**From:**  
**Sent:** 26 August 2016 18:25  
**To:** Salt, Roseanne  
**Subject:** RE: EXT || FW: National Grid Proposed - Substation at Chilling

**From:**  
**Sent:** 25 August 2016 15:04  
**To:**  
**Cc:**  
**Subject:** RE: EXT || Borehole Removal  
**Attachments:** 51829-05\_Figure 5.pdf

PROJECT: 51829-05 IFA 2 - CHILLING HORIZONTAL DIRECTIONAL DRILLING STUDY AREA				NATIONAL GRID PROPERTY HOLDINGS LIMITED			
EXPLORARY HOLE LOCATION PLAN				 <b>Advisian</b> WorleyParsons Group			
DRAWN BY PM	STATUS DRAFT	APPROVER	PAPER SIZE A3	DATE MAR 2016	SCALE 1:2000	OFFICE LEEDS	REV
				T +44 (0)117 825 1304 www.advisian.com			
				FIGURE 5

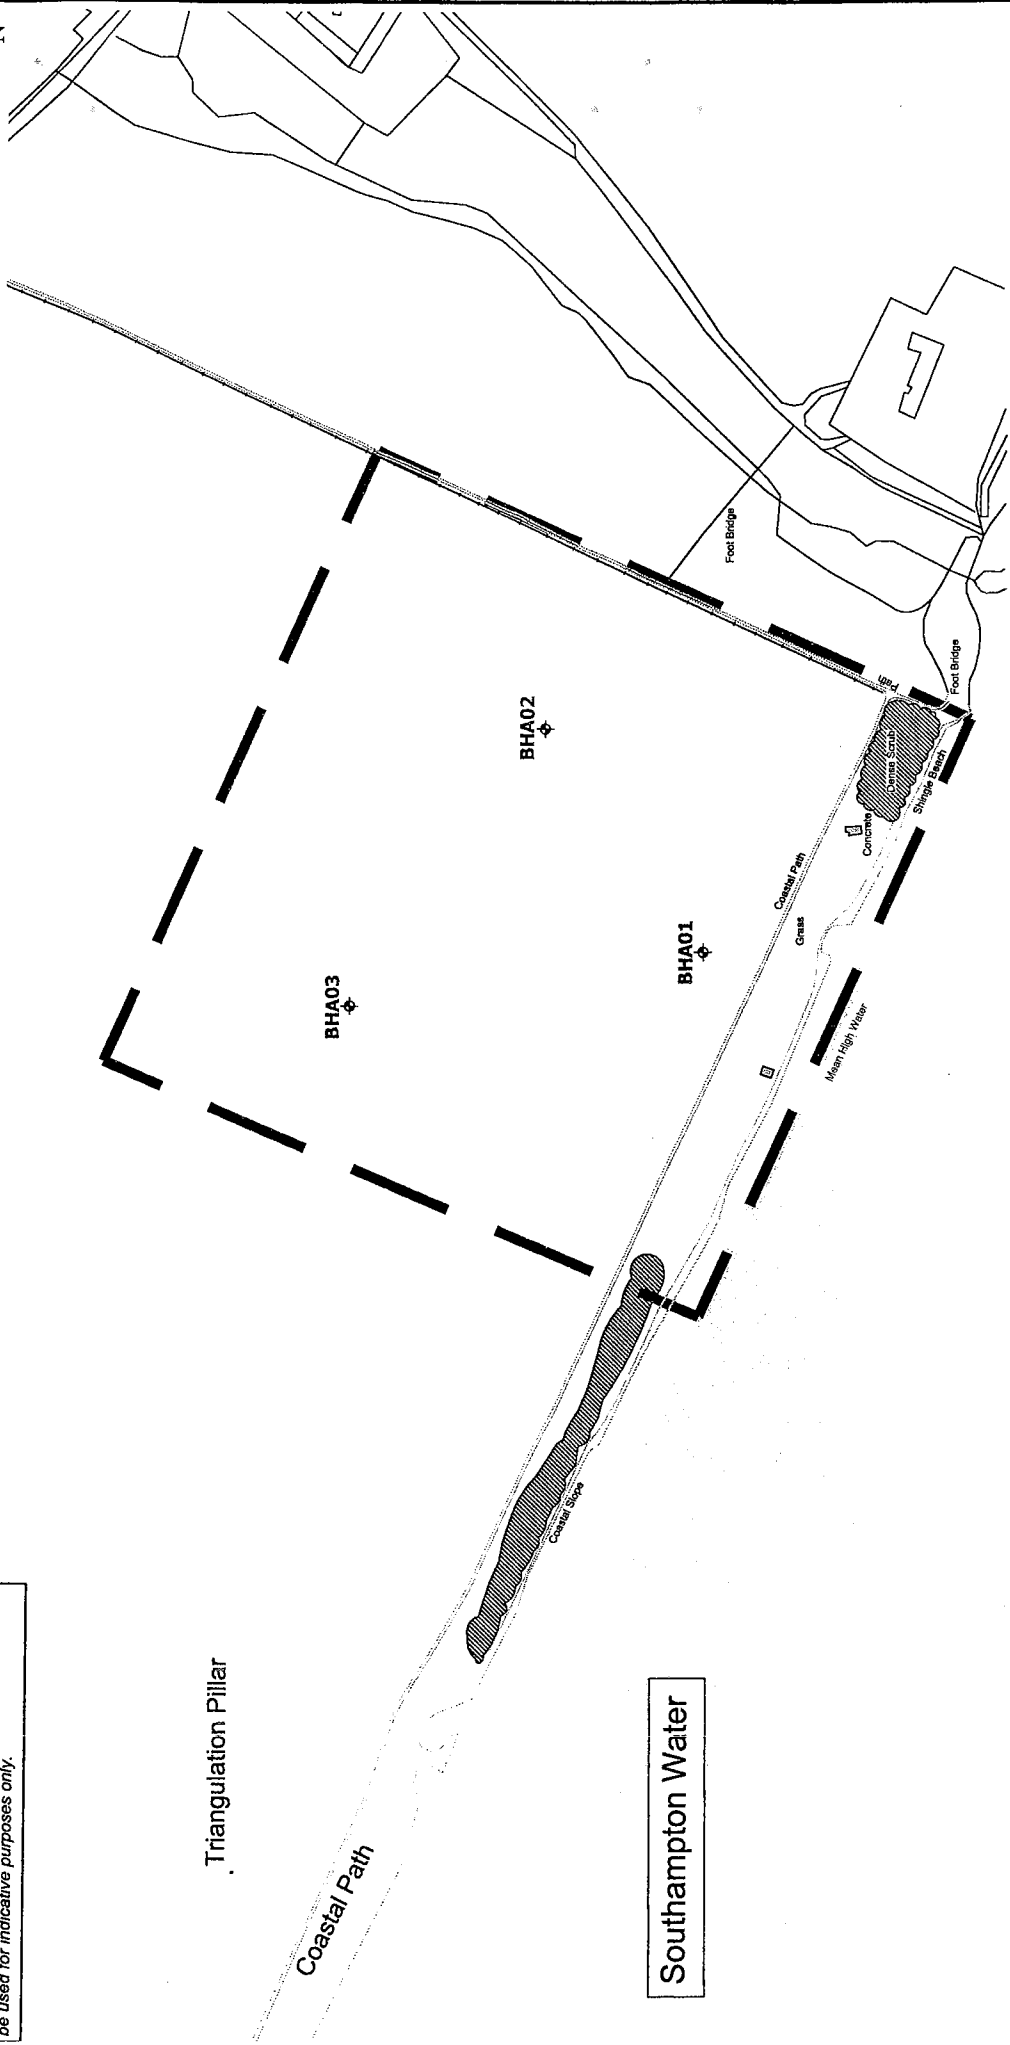
Please note that the site investigation scope of work completed was notably less than that shown on the 'IFA2 – Chilling Licence Plan' [redacted] attached to her email. The trial pits shown were not undertaken, just the drilling of the 3 boreholes. I've attached a plan from our consultants which confirms the locations of the boreholes.

In January 2016 three boreholes were drilled within the agricultural field at Chilling. The boreholes were drilled to a maximum depth of 30 m. Following drilling, the boreholes were installed as groundwater monitoring wells. This comprised the insertion of 50 mm diameter pipe into the borehole with the surrounding annulus being backfilled. With the spring barley having now been harvested the intention is to return to site to decommission the boreholes.

1. Remove all surface 'well-head' material, i.e. the concrete chamber and well cover;
2. Hand excavate to 1.3 m below ground level (bgl) and cut off the pipework to a minimum of 1.2 m bgl. Note that pipework will remain beyond this depth;
3. Pump a grout mix into the borehole. Note that any groundwater displaced via the infilling with grout will be allowed to soak away into the ground;
4. Once the borehole has been filled a 0.3 m thick concrete cap will cover the top of the borehole, i.e. from 1.3 m bgl to 1.0 m bgl. The concrete cap will be approximately 0.3 x 0.3m square.
5. From 1.0 m bgl to surface the pit will be infilled with subsoil and topsoil. The ground surface will be graded to match in with existing.

With reference to the proposed Advisian methodology it is acknowledged that equipment, comprising 50 mm vertical pipe with concrete caps, will remain at the property from a depth of 1.0 m to up to c.30 m. When considering an alternative methodology whereby the pipework is fully removed, the following should be noted:

I have no objection to the boreholes being de-commissioned as suggested (I think this is perhaps a better term to use rather than 'removed' if some materials are to remain underground). I am happy for you to proceed on this basis due to the justifications that have been given which claim it is less intrusive, able to be carried out effectively and the works are able to be completed within a shorter time frame than a full removal of all apparatus/infrastructure. All of this means that the drilling of the next crop will not be delayed and no are likely to be affected.

Assuming that clients have no objections, please continue with the de-commissioning works as described in the below email string.
